# HIDEOUT, UTAH TOWN COUNCIL REGULAR MEETING

May 28, 2020

**Staff Report – Engineering Department  
Town of Hideout Planning Commission**

**Date:** April 28, 2020  
**Applicant:** Nate Brockbank  
**Subject:** Deer Springs Phase 1 Plans – Amended  
**Recommendation:** Final Approval

JACKSON ENGINEERING  
3376 STONEHILL LANE  
COTTONWOOD HEIGHTS UTAH 84121  
PHONE (801) 558-5293

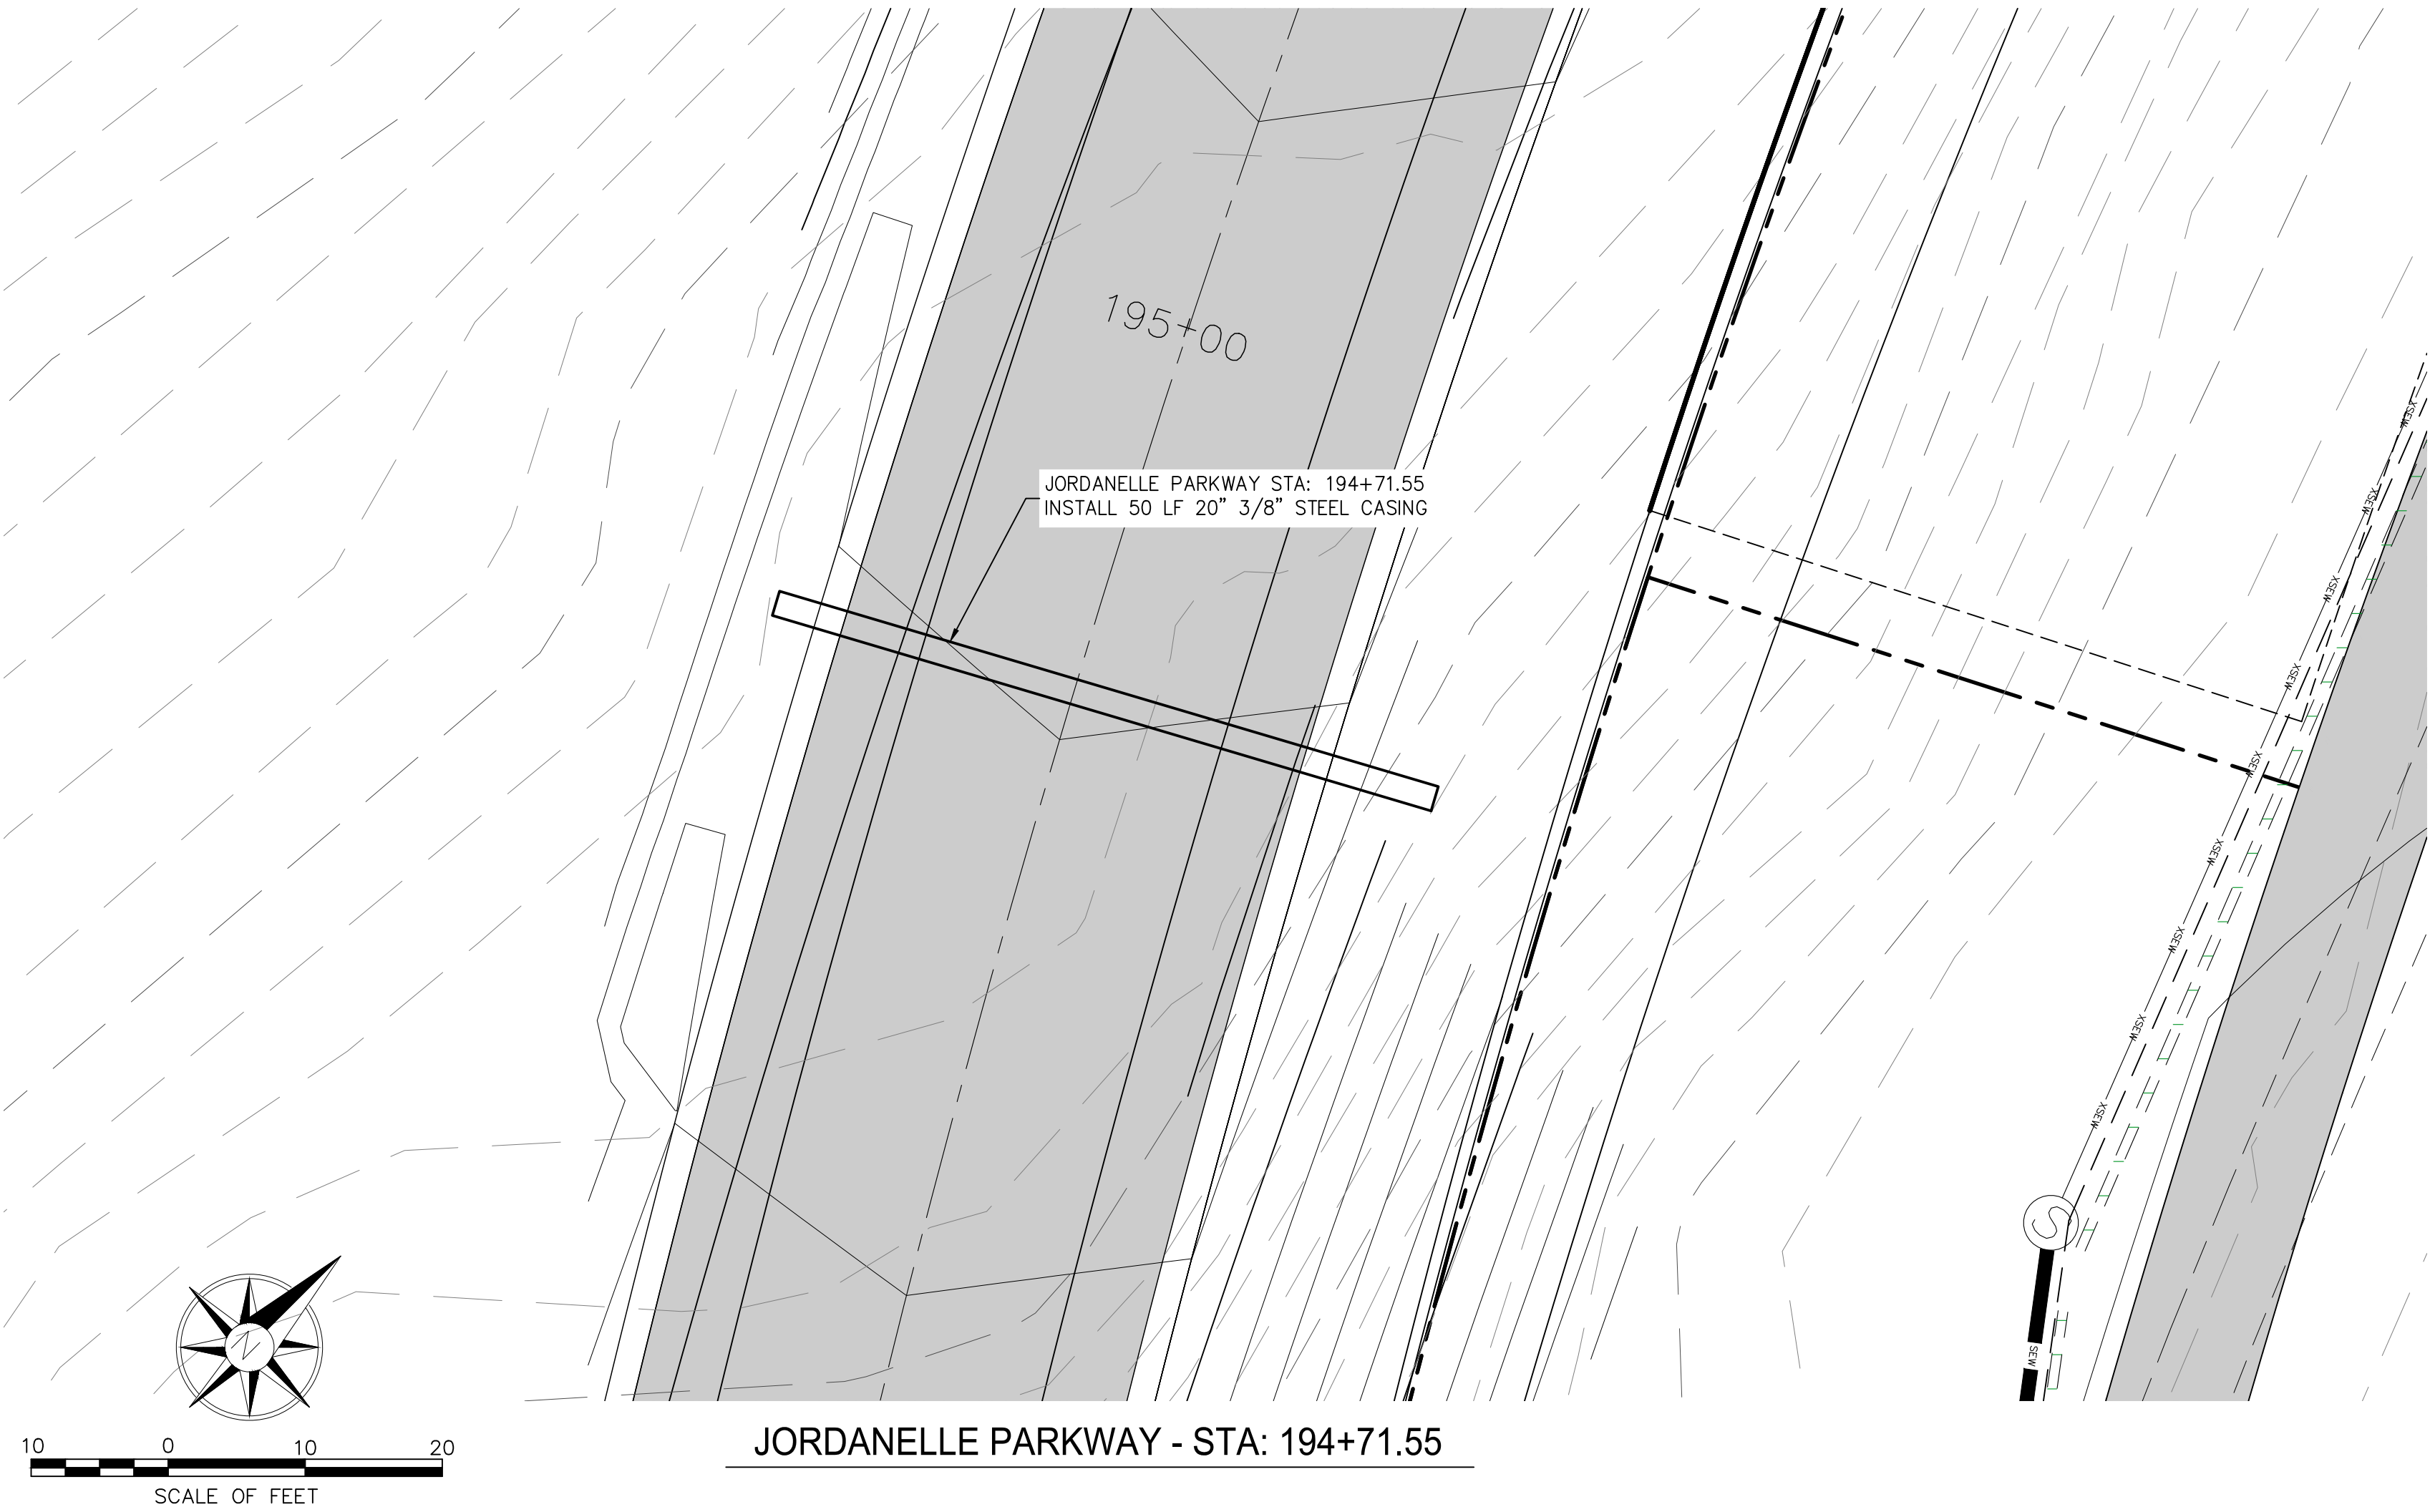
Pages PP1.4 through PP1.6 include details on placement of casings under Jordanelle Parkway for future connection. We understand that the placement of these connections and stub-out from Jordanelle Parkway is time-sensitive. However, a full plan set must be submitted and approved prior to construction of the roadway through the Deer Springs development to Jordanelle Parkway

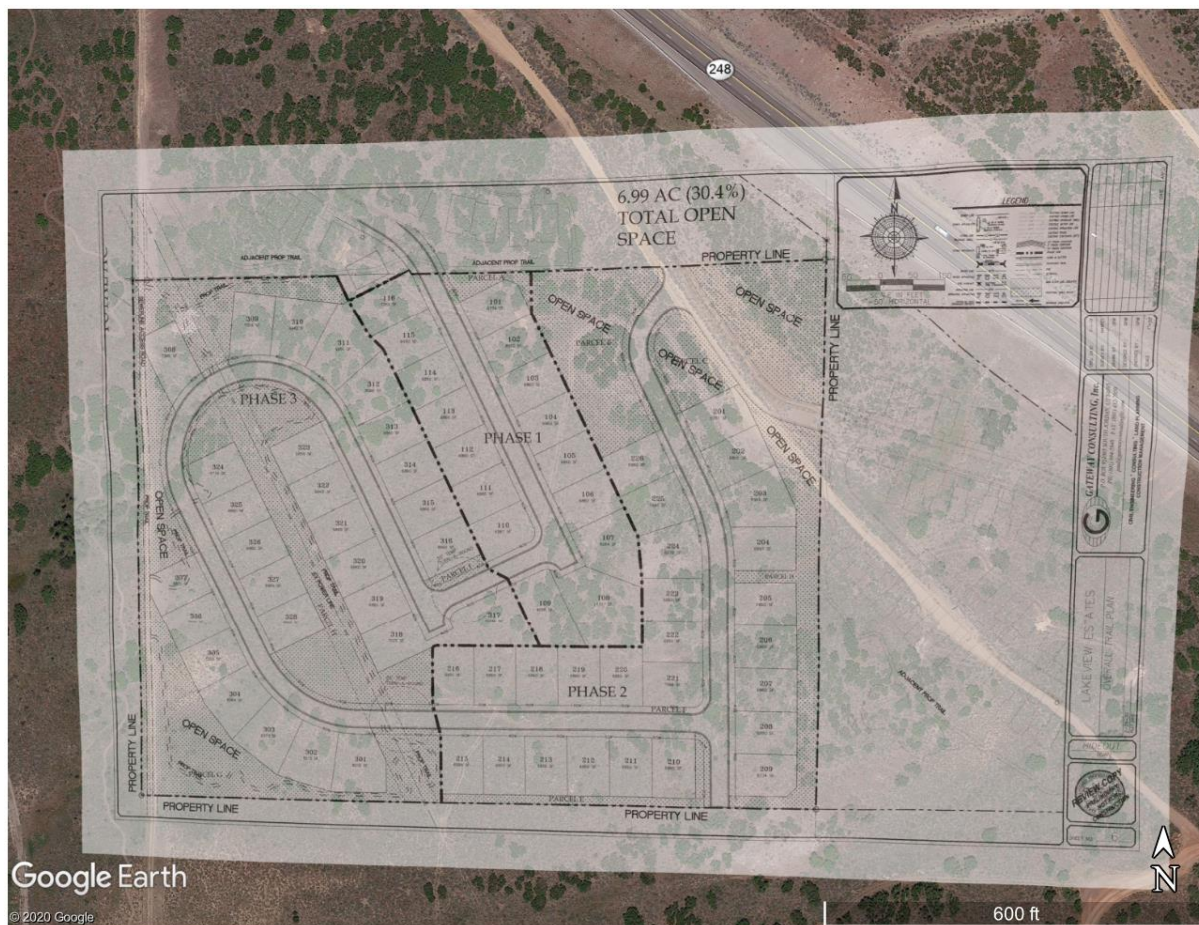
We have reviewed the attached concept maps for the revised plan for Lakeview Estates. The development is in the preliminary stage and has been presented before Planning Commission and was recommended for presentation before Town Council. Town Council requested that the agenda item remain open at the preliminary stage for the developer to continue work on reducing retaining wall size by choosing certain lots to limit the front setback. We are satisfied with the changes to the plan set with regards to retaining wall height reduction.

1. Ensure adequate offset from the existing gravel road to any structure. Structures such as the dog wash must meet the 20 foot front and rear setback requirements. **Condition of Approval. Will be verified at Final.**
2. Based on a recent site walk, we have identified several culverts under the existing gravel road managing drainage channels through the property in its current state. These drainages will need to be properly managed. **Condition of Approval. Will be verified at Final.**
3. The concept maps were presented to the Kent Cuillard, Director of Public Works and he is unsatisfied with the locations of the snow storage areas and general ability to plow the roadways at the center of the development (at the two hammer-heads). **Resolved with the new concept design.**
  - We are satisfied, however, with the ratio of surface area dedicated to snow storage to new roadway area.
